LAND USE APPLICATION - COMPLETENESS REVIEW

Subject Property:	2561 Center Street NE
Reference Number:	24-113032-PLN
Application Type:	Partition and Class 3 Site Plan Review
Date Application Accepted:	August 21, 2024
Applicant:	Steve Kay for Cascadia Planning & Development Services steve@cascadiapd.com
Contact:	Tim Lawler for Greenlight Home First LLC tim@gl-dev.com

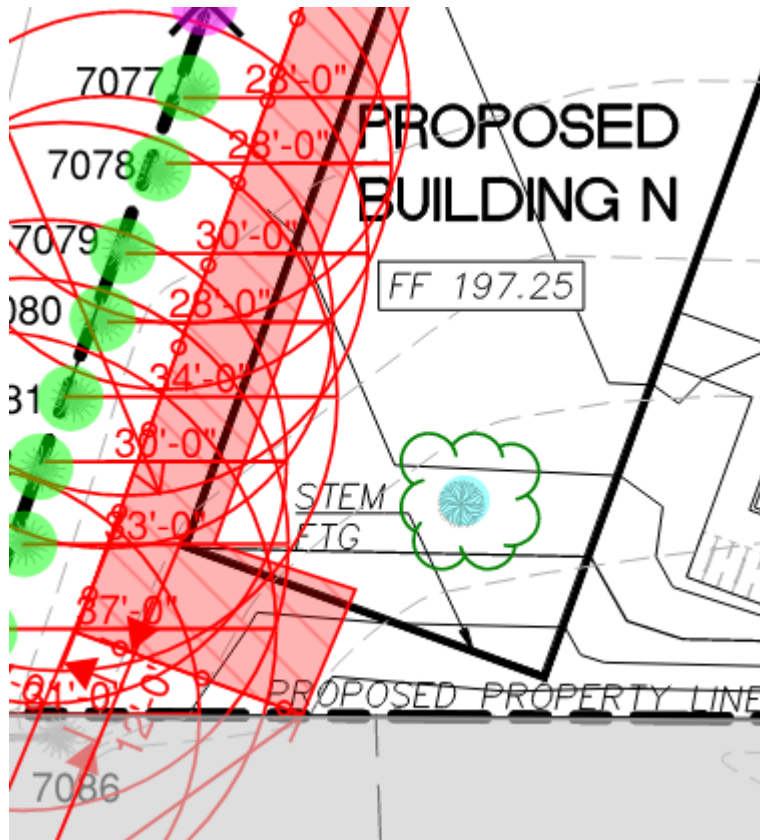
Chapter 808 – Tree Preservation		
Tree Plan	<p>The tree plan submitted needs more information or revisions in the following areas:</p> <ul style="list-style-type: none"> ▪ The tree plan seems to reflect the older configuration of the site. Please update the underlying development plan to demonstrate how the proposed development, as it has been modified, will affect the tree's critical root zones. ▪ Please show the percentage of disturbance for Trees 7077-7085 to verify that the amount of disturbance is under the 30 percent threshold. If more than 30 percent is affected, a Tree Variance may be required. ▪ While the Variance for the CRZ was approved with the first application for Tree 4098, please include the tree's CRZ and protection measures with this application as well, shown with the new proposal of Phase II, to ensure that the findings remain the same, or if changes need to be made to the area. In addition, the last Phase I Tree Protection Plan referenced does not appear to have the accurate CRZ shown for the tree. ▪ Tree 4147 is indicated on the plan for removal, but is listed as exempt. Trees that are exempt can be removed from the plan to avoid confusion.

- There is a tree shown where Building N is proposed (in blue and clouded below), with no identifying number indicated in the tree inventory, exempt or otherwise. Please provide identifying information and plans for this tree, and revise any counts as necessary.
